ADDENDUM #1 -- CPS RFP 20/69 --

BENTON ELEMENTARY MOBILE CLASSROOMS SITEWORK PACKAGE

DATE: AUGUST 21, 2020

Benton Elementary Mobile Classroom Sitework Package

SHEET: CE 0

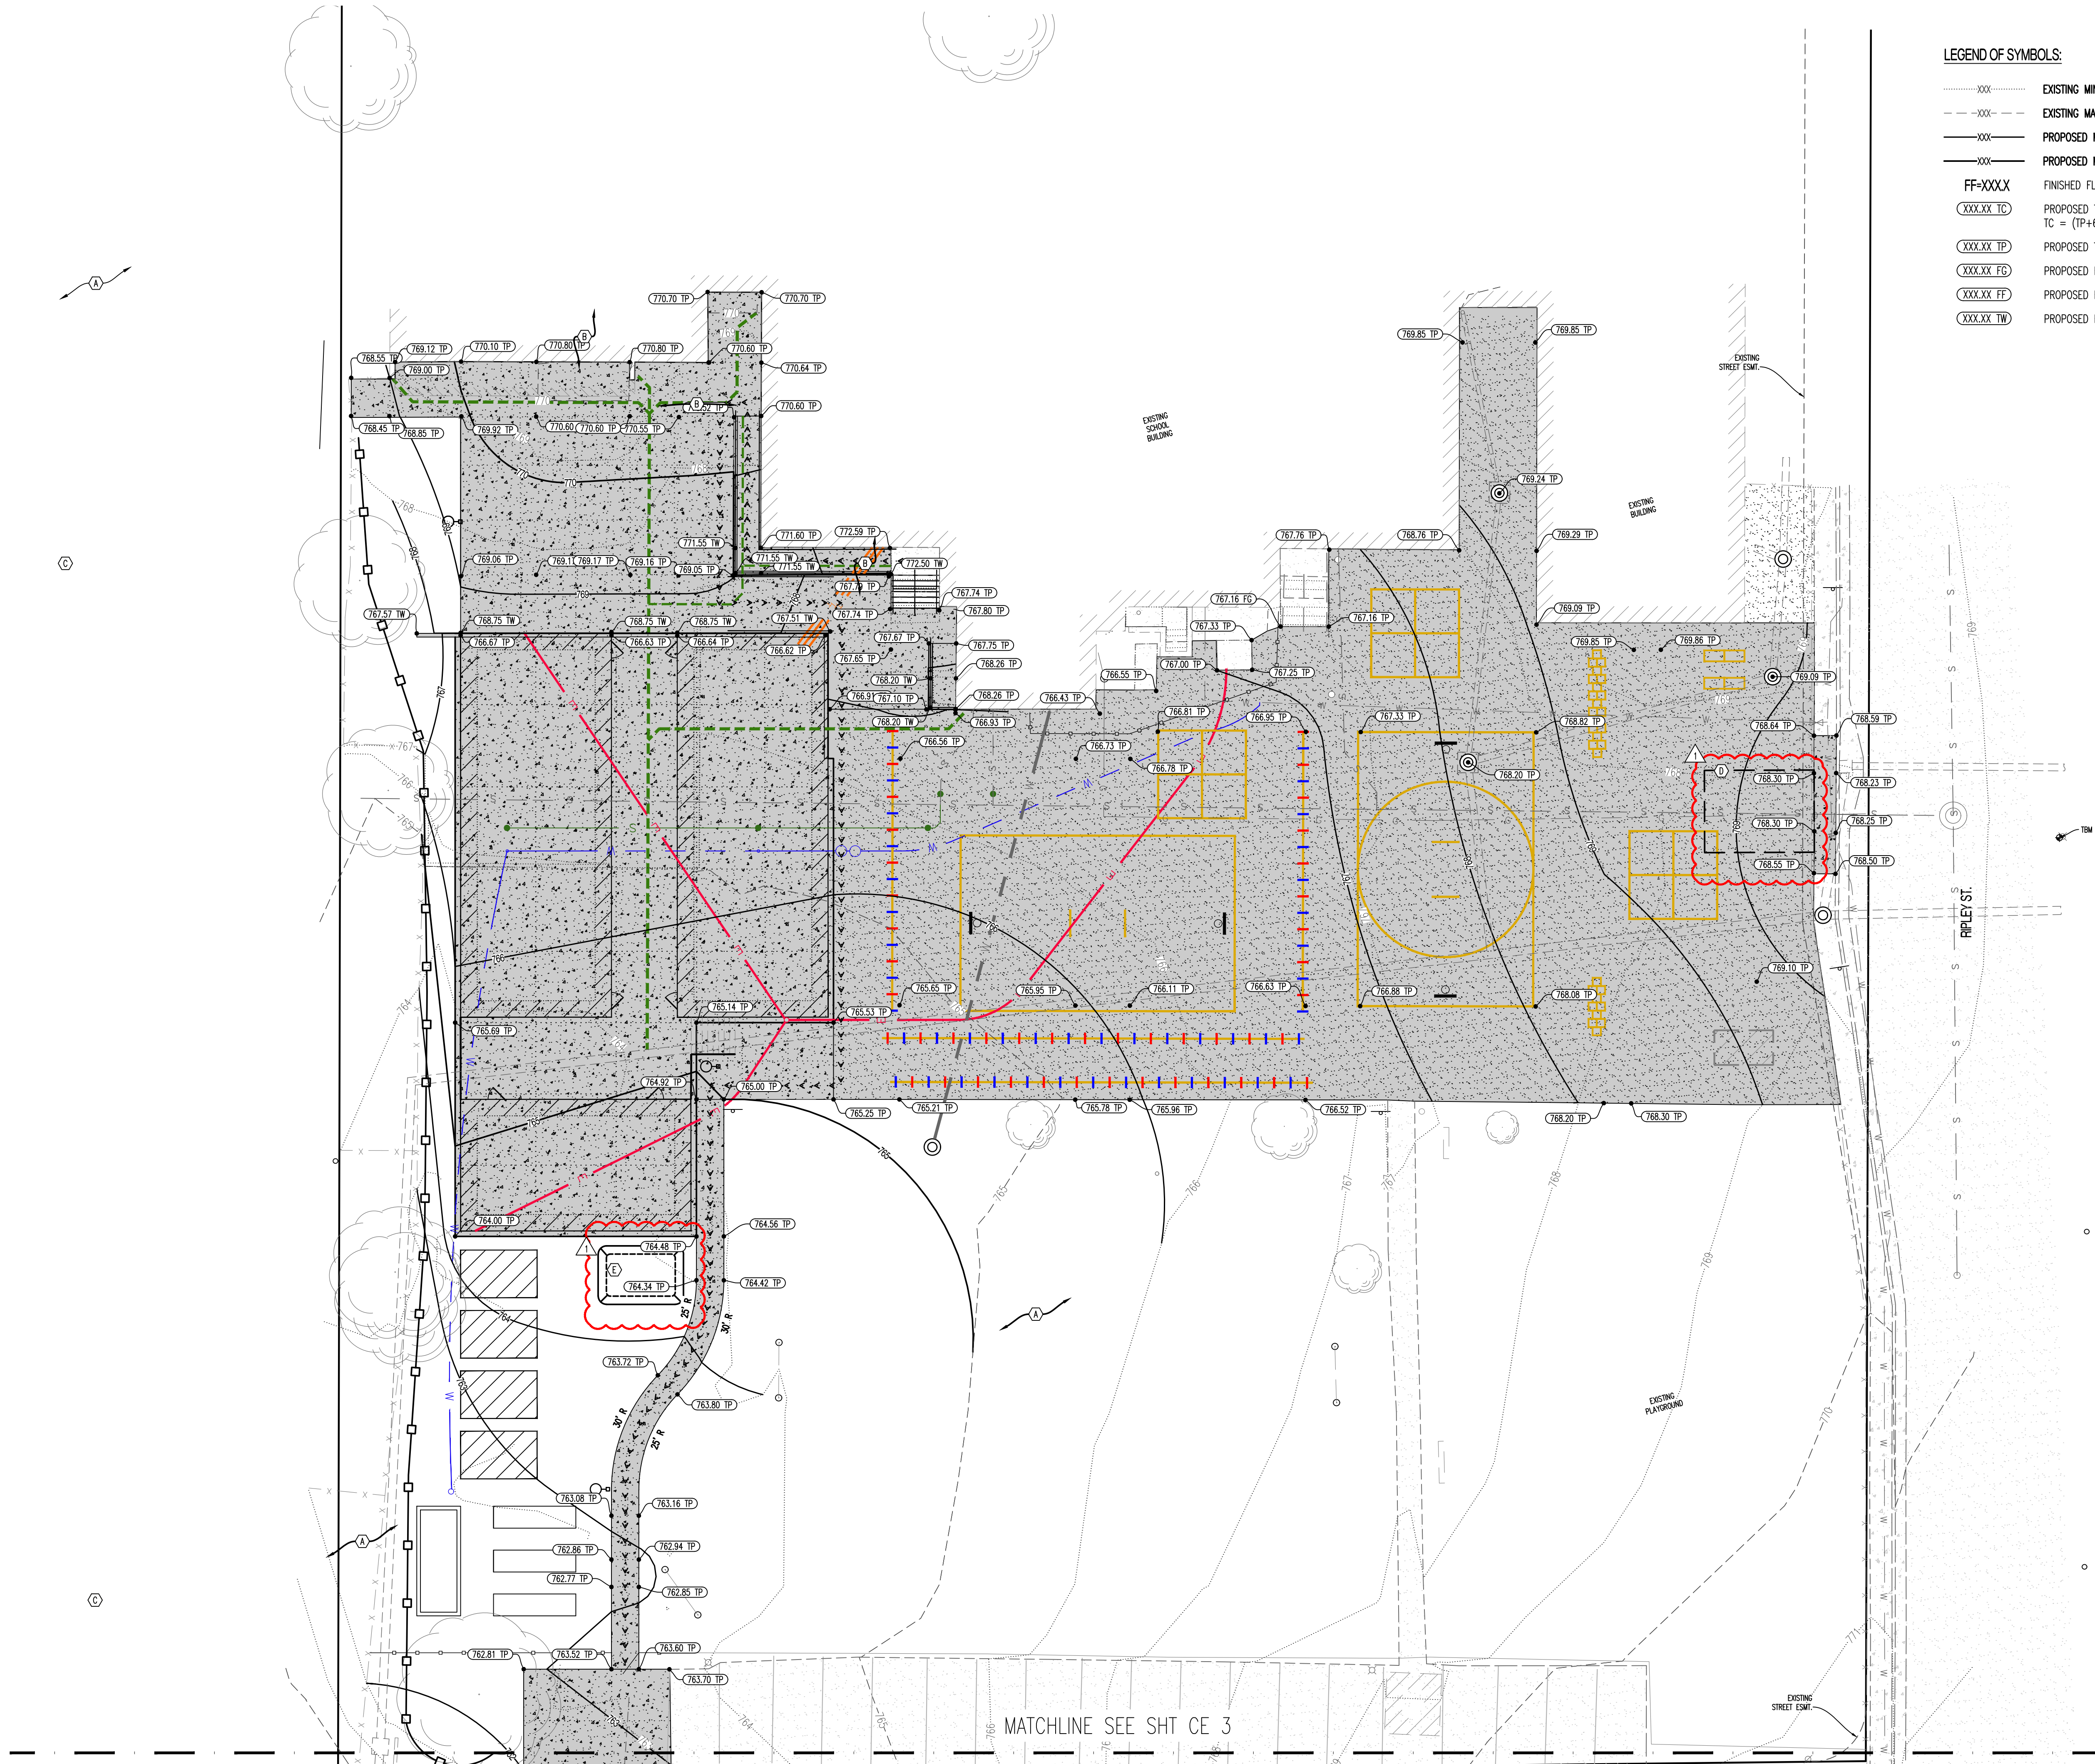
1. Sheet CE0
 - a. Updated the zoning designation for the property.
 - b. Added a general note clarifying that City of Columbia will require a traffic control plan from the contractor prior to performing any work in City right of way.

SHEET:
CE 2

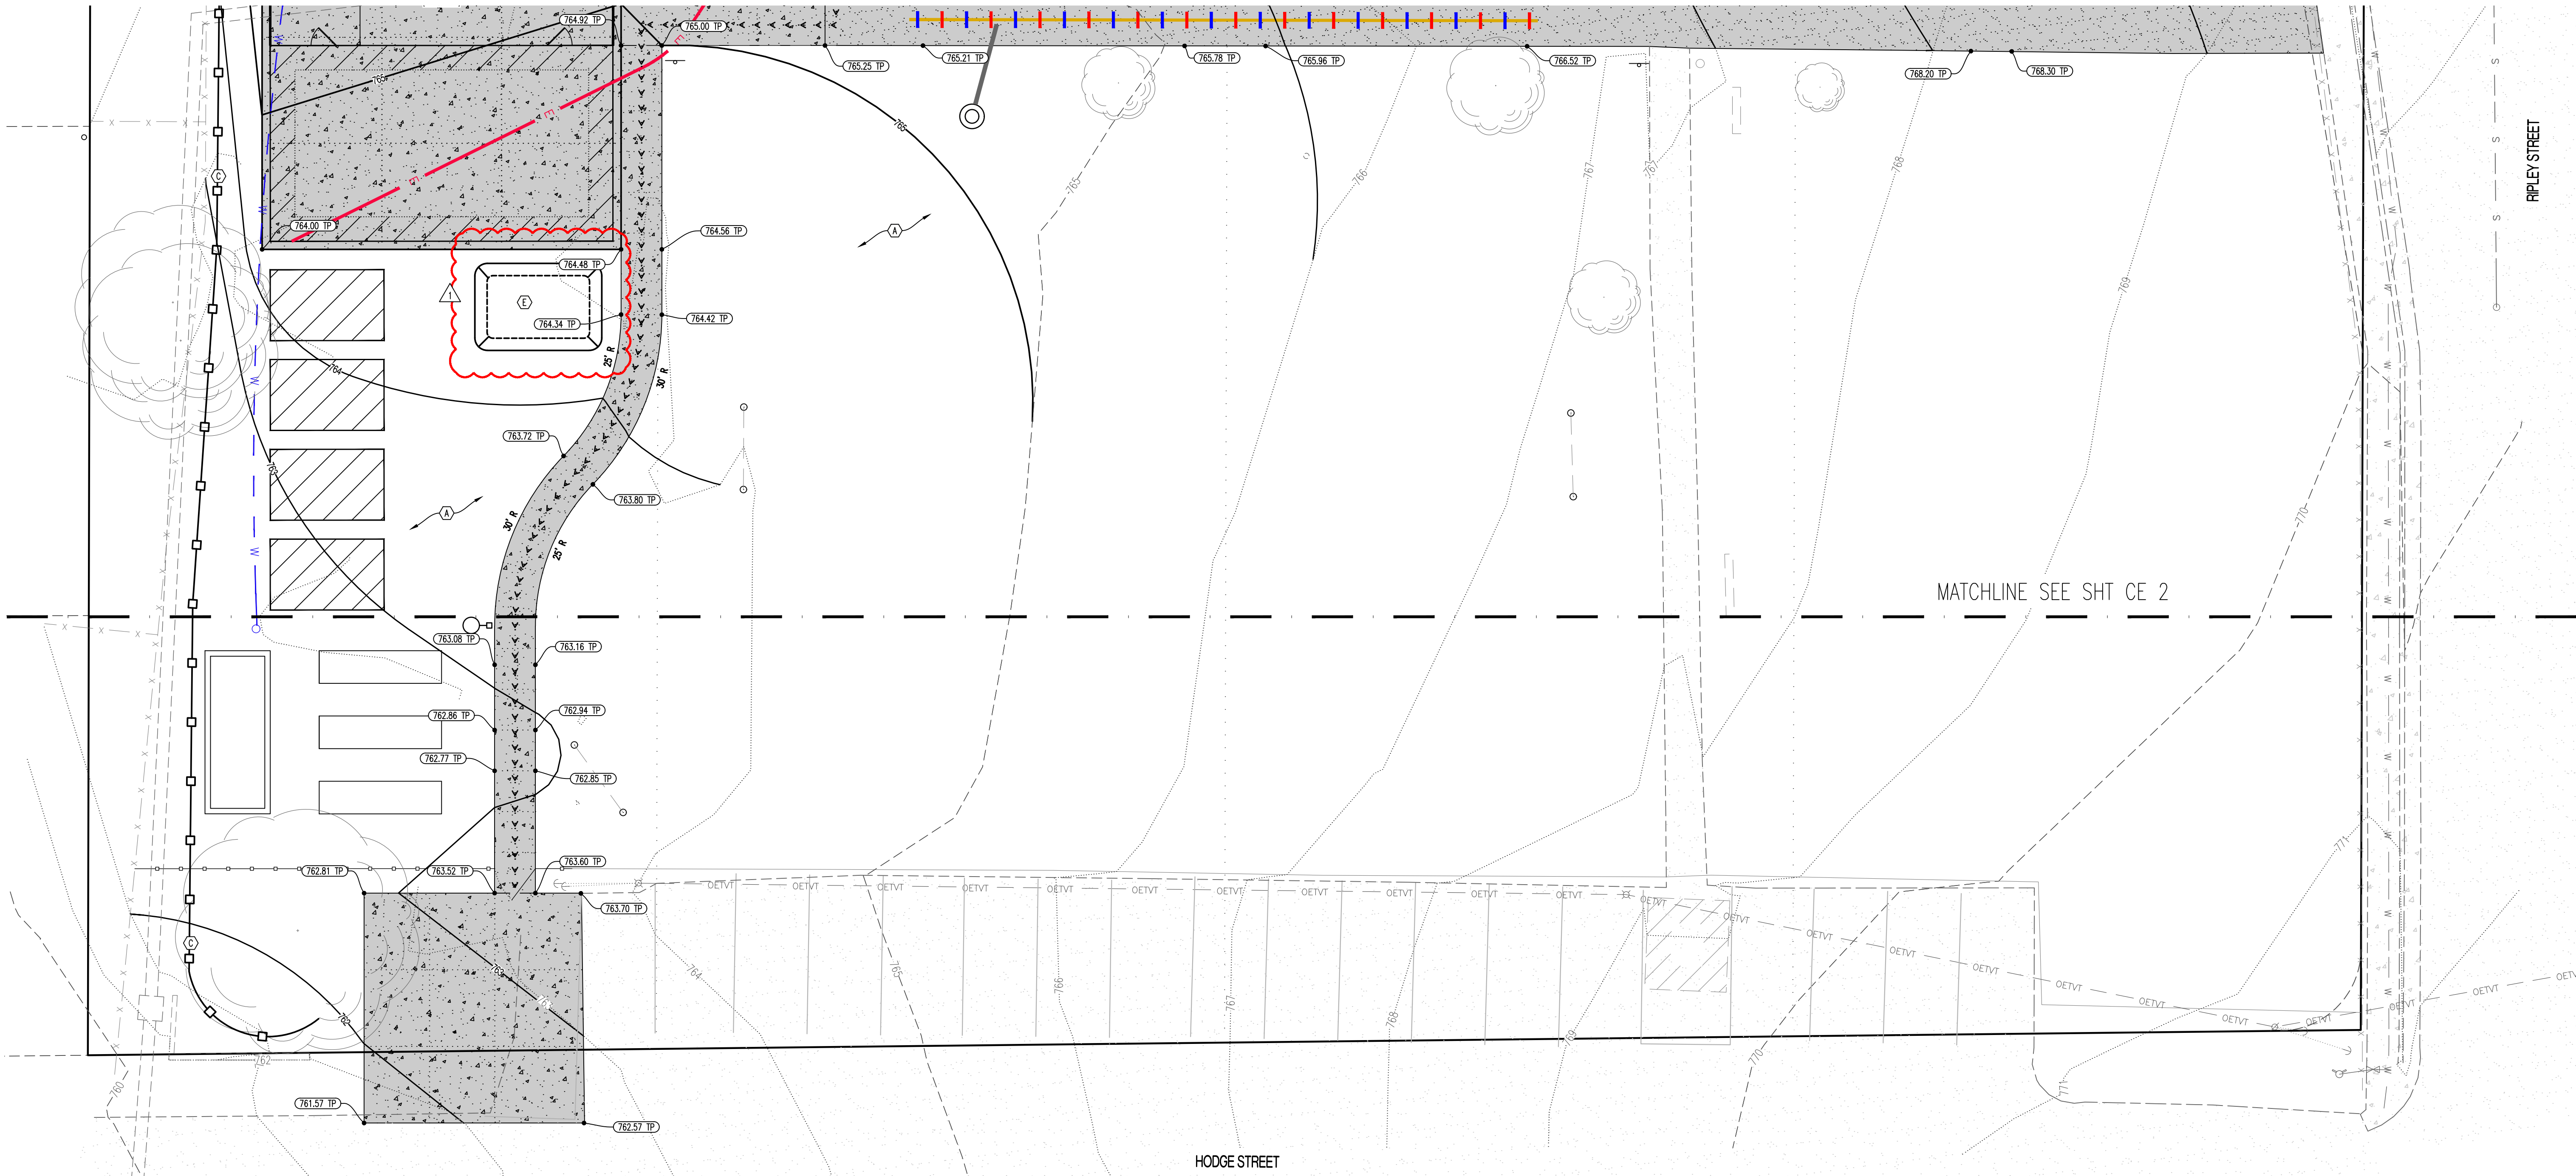
2. Sheet CE2
 - a. Reference to Silt Fence detail added.
 - b. Construction Entrance and street sweeping notes added.
 - c. Concrete Washout Facility requirement added.

- d. City of Columbia stockpiling requirement notes added.
 - e. Erosion Control narrative added.
3. Sheet CE3
 - a. Reference to Silt Fence detail added.

SHEET:
CE 3

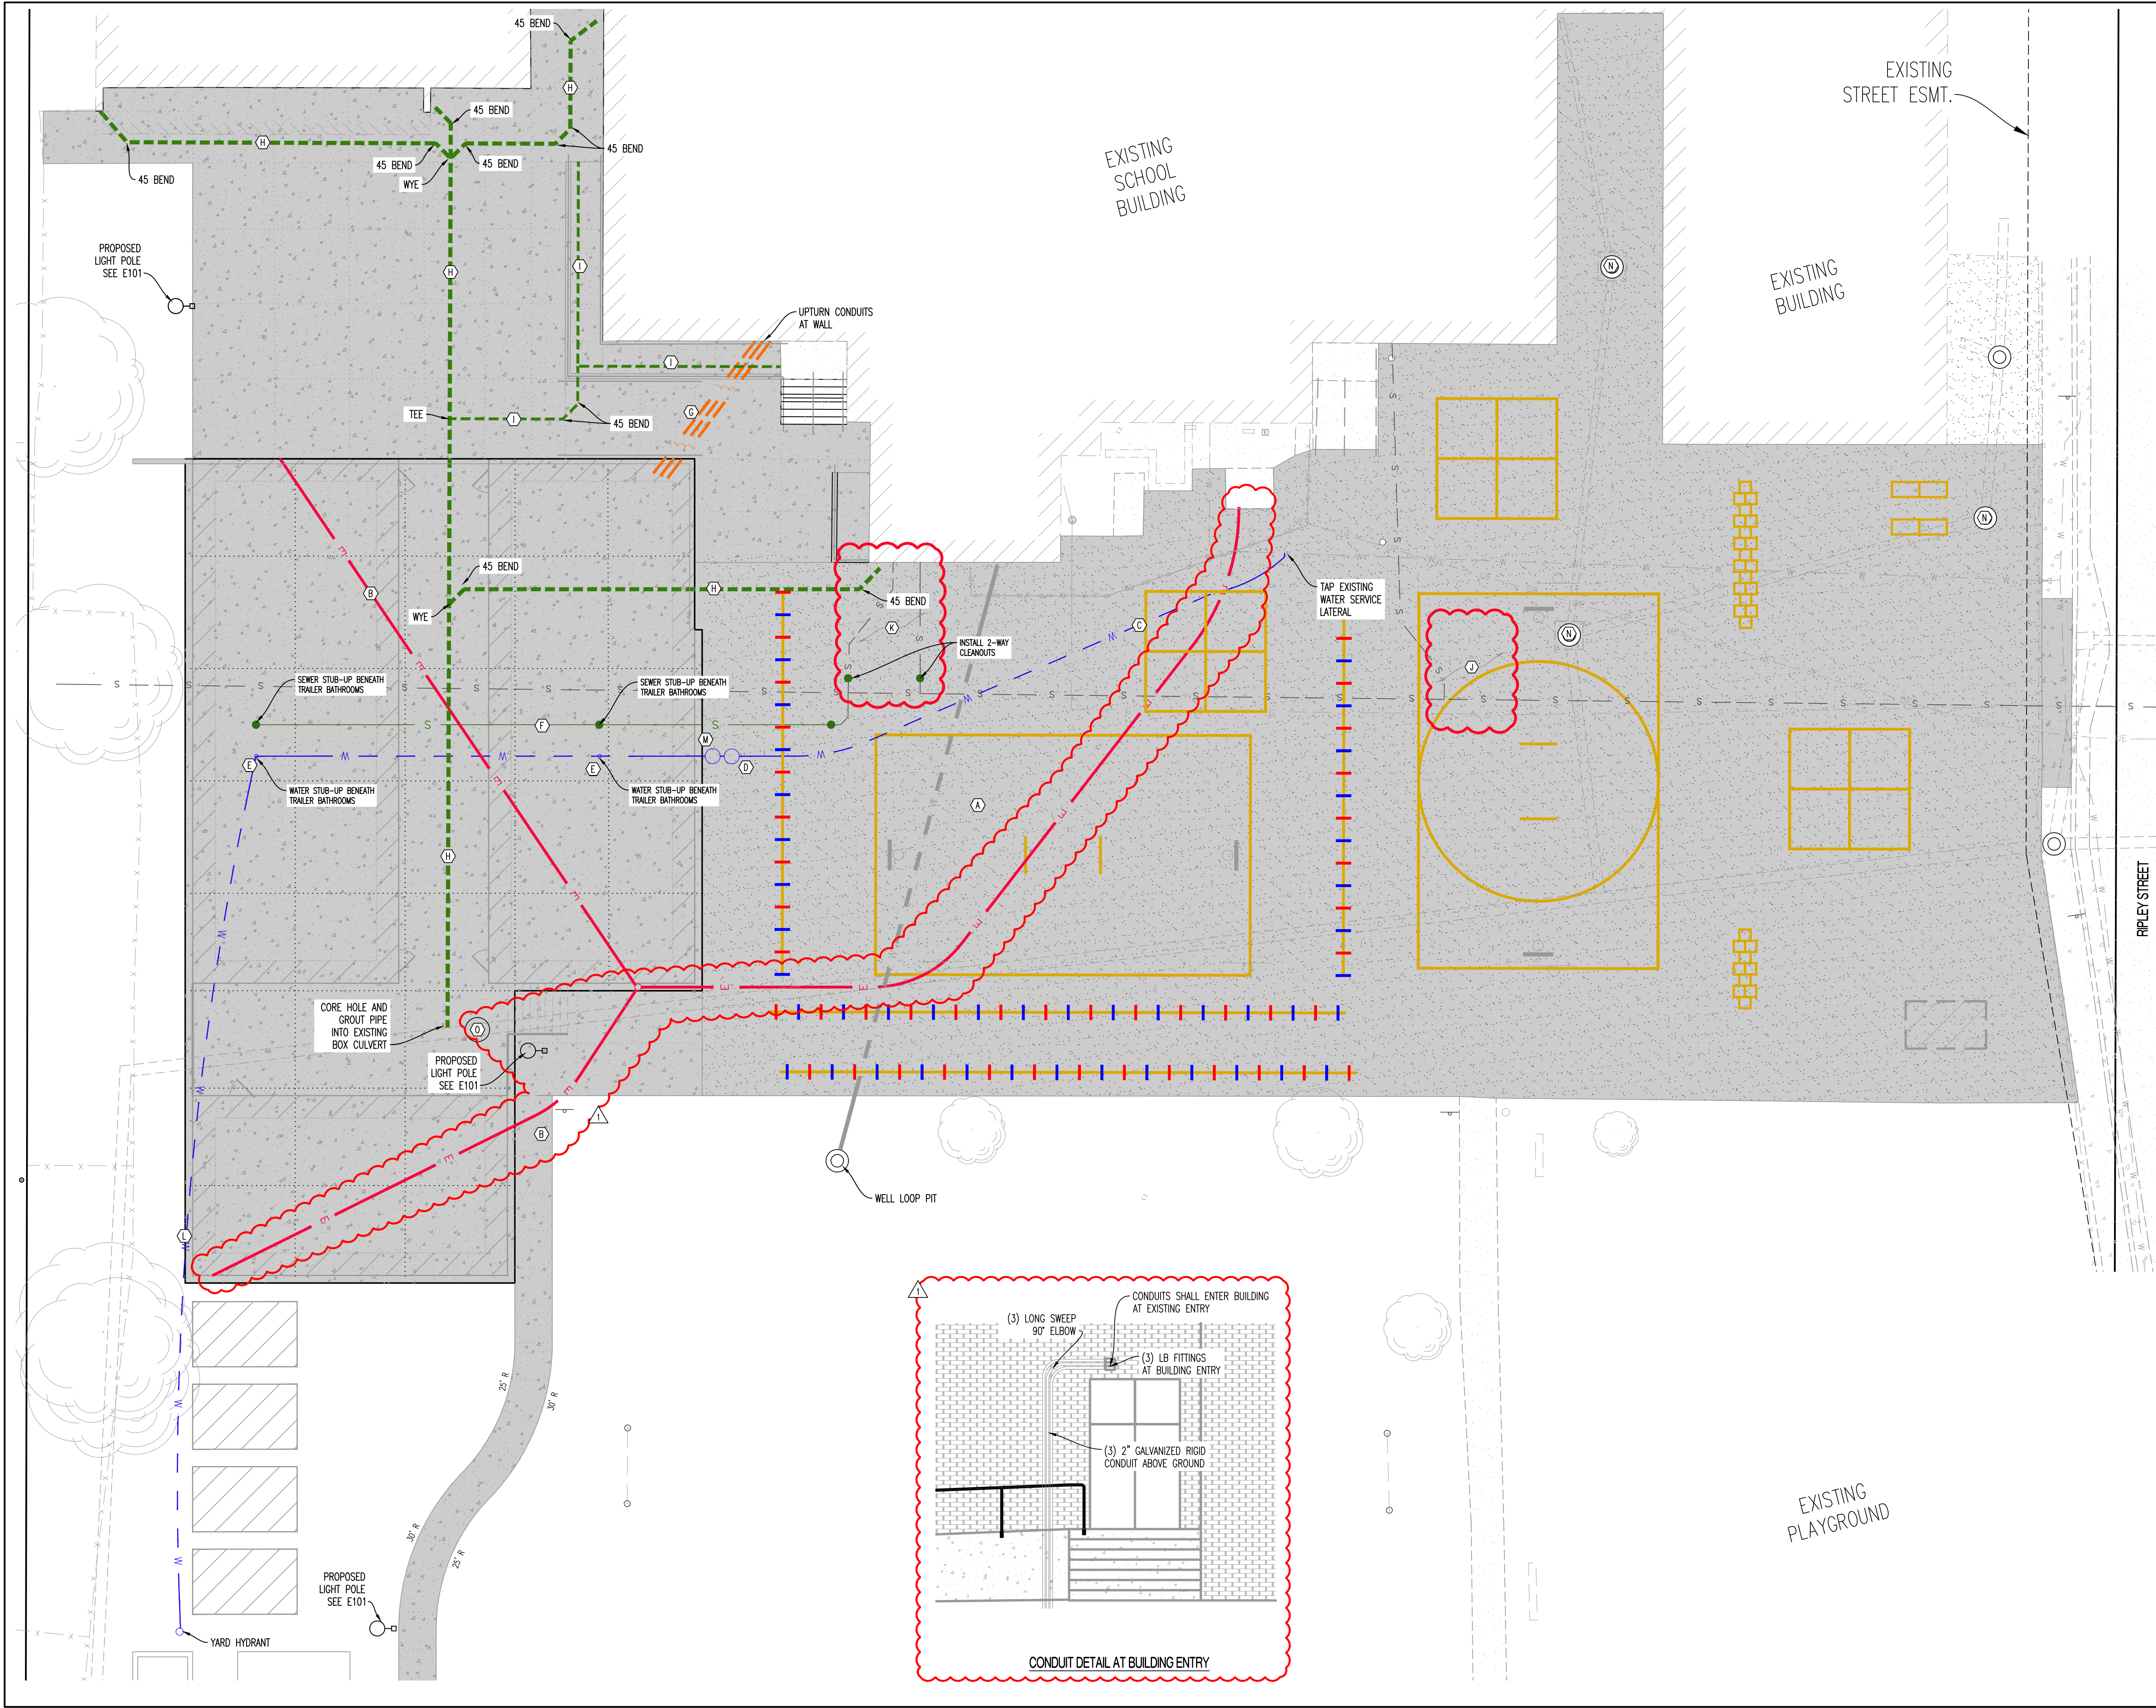
- b. Construction Entrance and street sweeping notes added.
 - c. Concrete Washout Facility requirement added.
 - d. City of Columbia stockpiling requirement notes added.
